Town of Davidson, NC
Design Review Board: Staff Analysis
April 17, 2019

Project: Accessory Structure (over 650 square feet)
Location: 138 Meadowbrook Ln.
Applicant: Brent and Rachelle Zande
Designer: KP (Kevin Simon)
Planning Area: Village Infill

GARAGE STRUCTURE 138 MEADOWBROOK LN
(Name of Project)

1 FRONT ELEVATION
A2 SCALE: 1/4" = 1'-0"

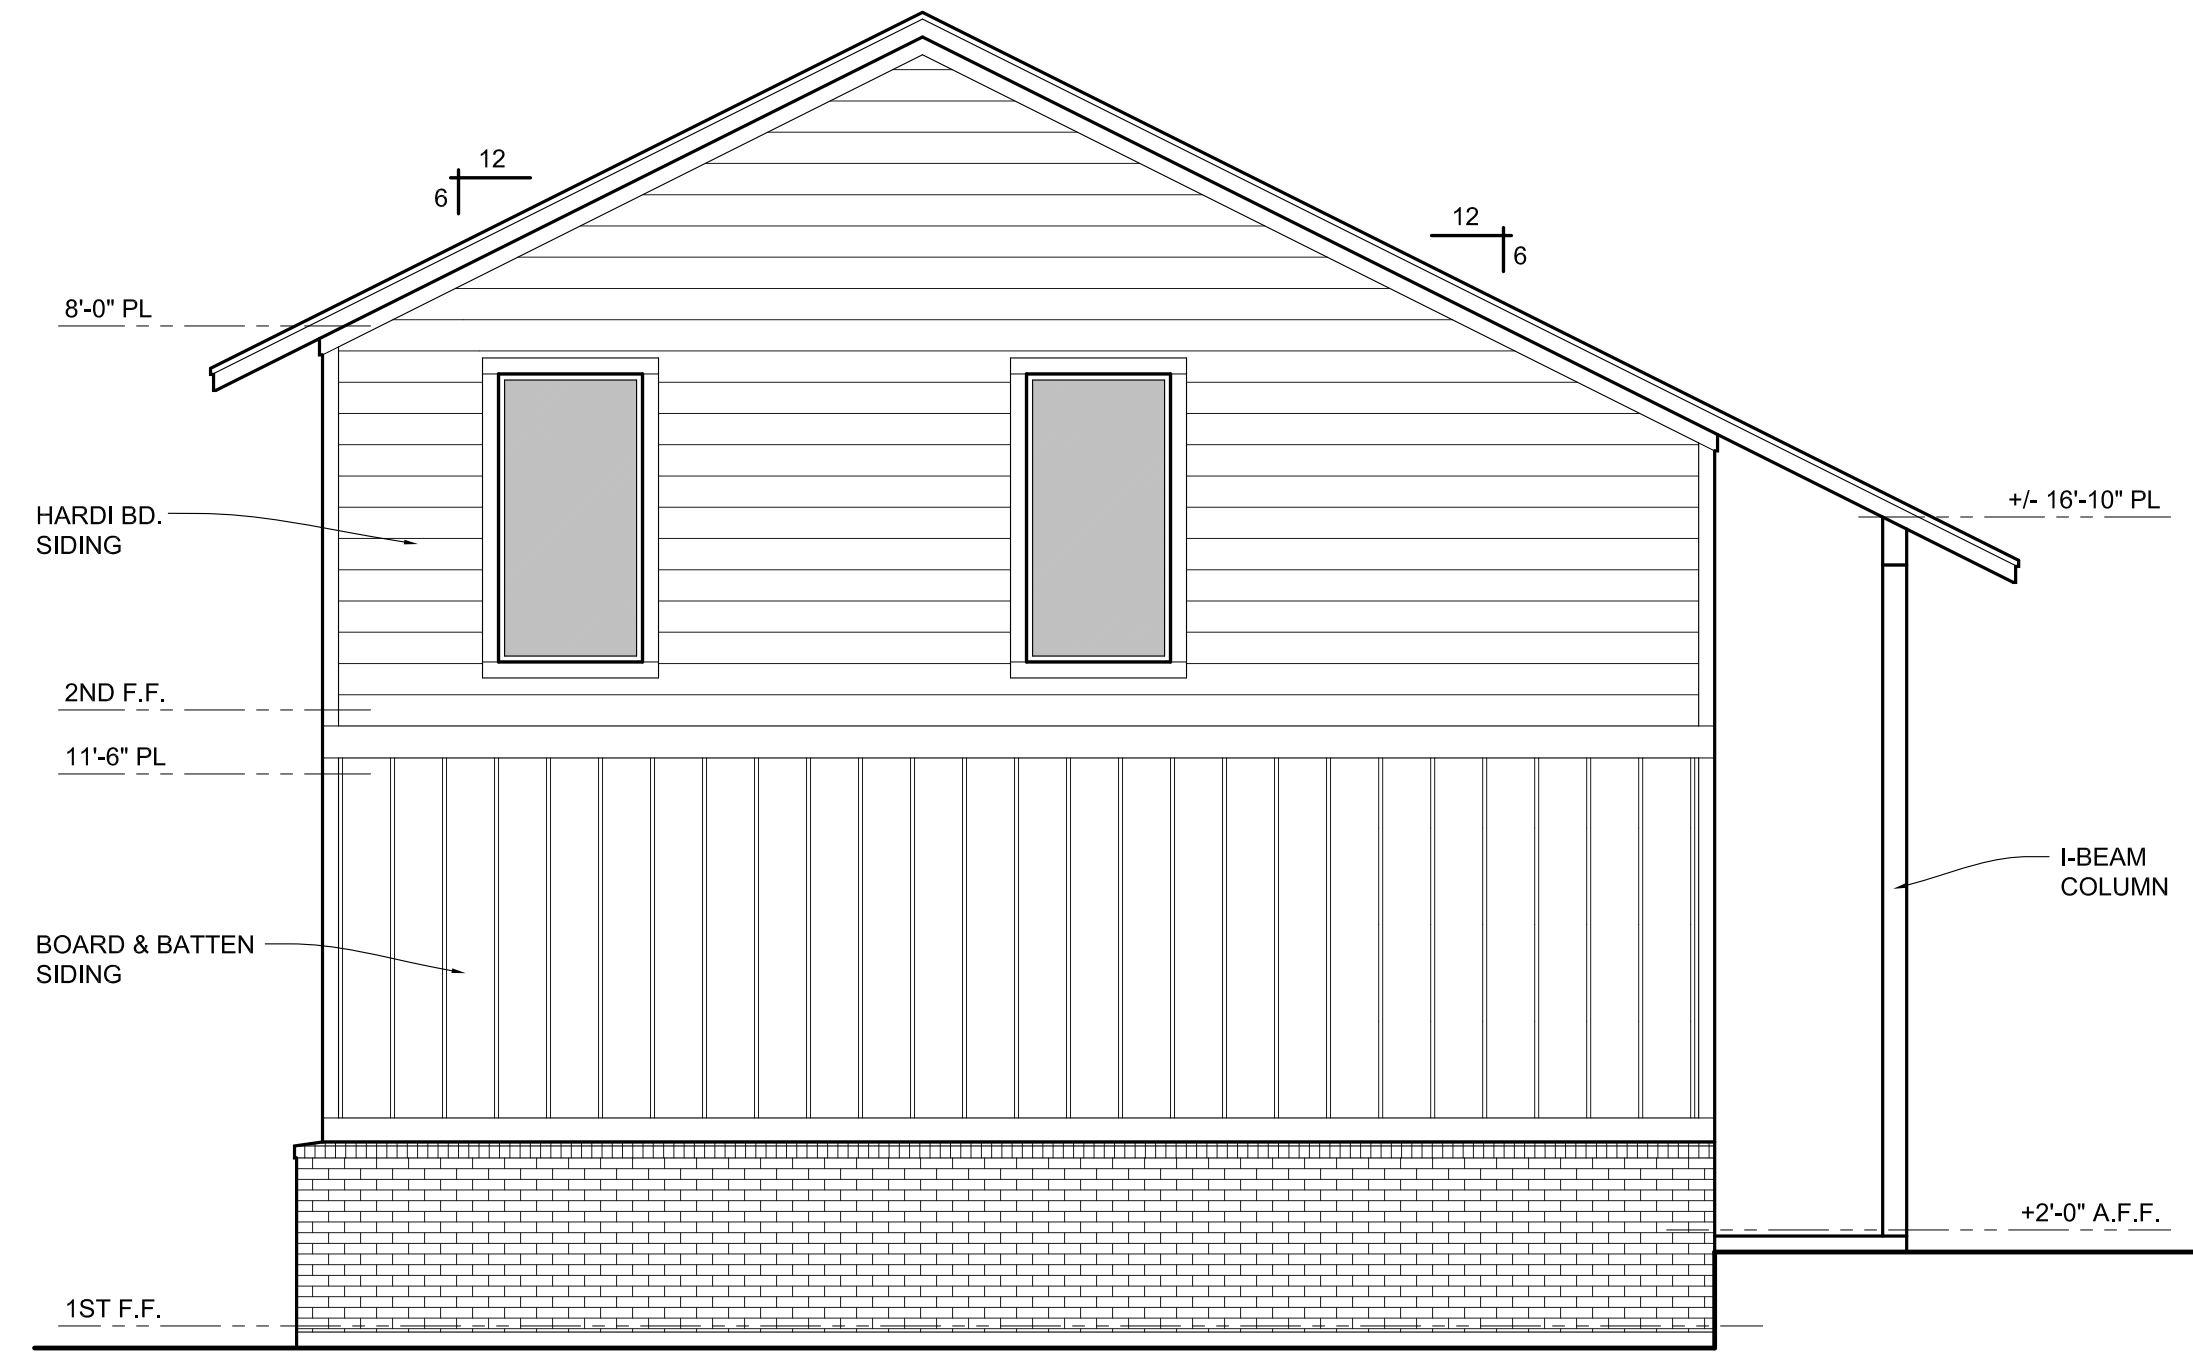
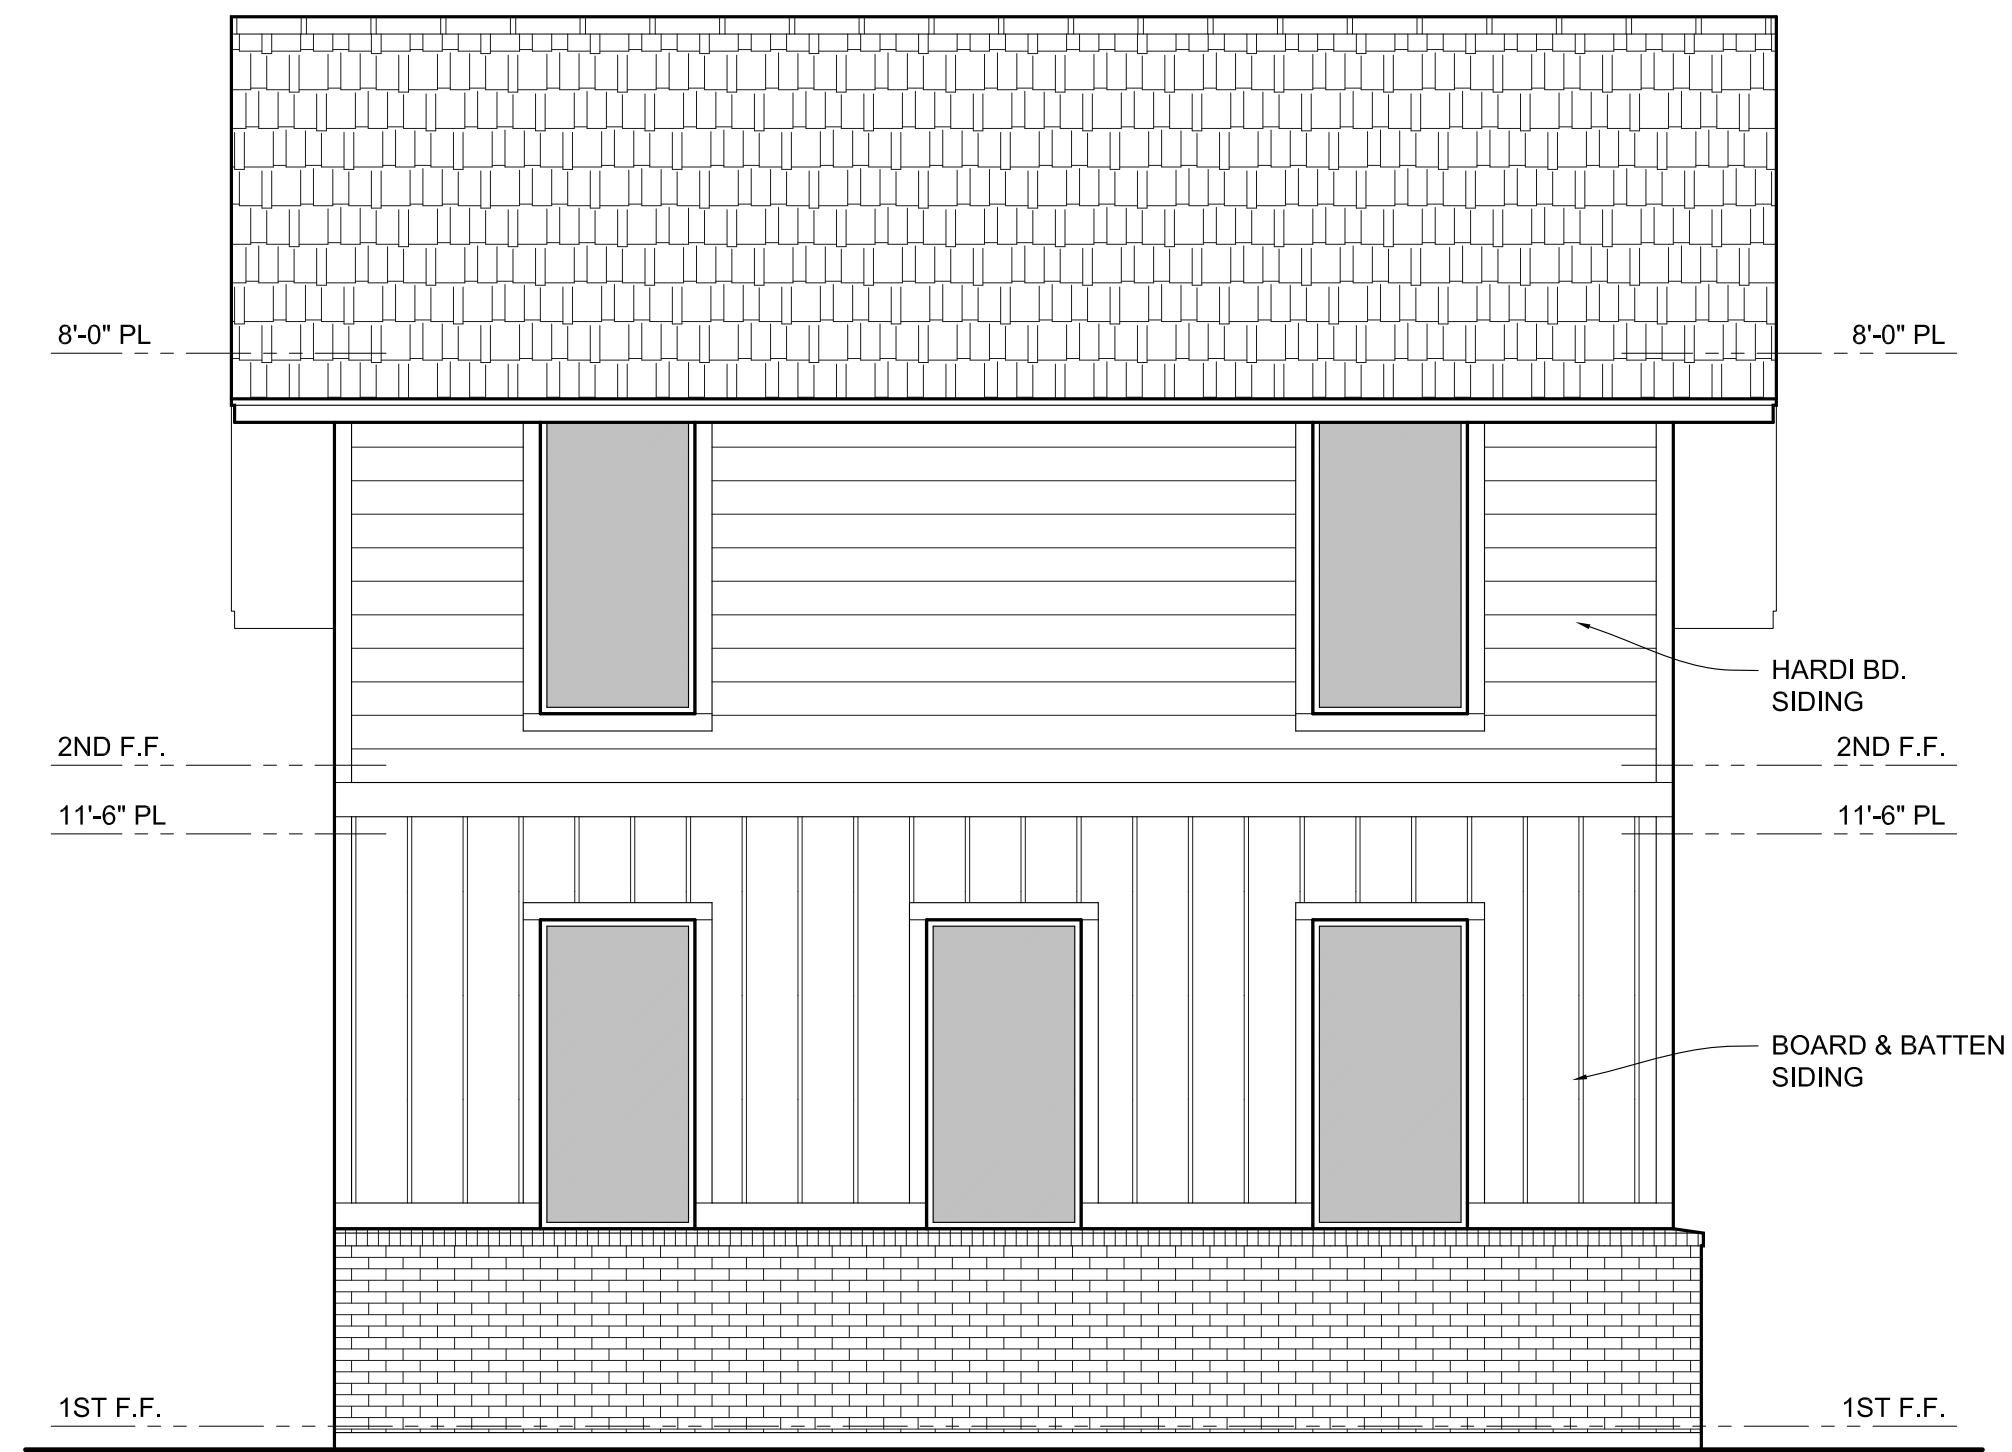
Lighting is not shown on the garage elevations, however the structure will have two sconce lights, one on each side of the garage door on the front elevation. Sconce lights will match lights on the home (see sconce lighting example below). Additional recessed lighting will be located on the left side of the structure in the ceiling above the covered porch. Flood lights shown on the electrical first floor plan on page four of the plans are inaccurate. There will be no flood lights on the structure.
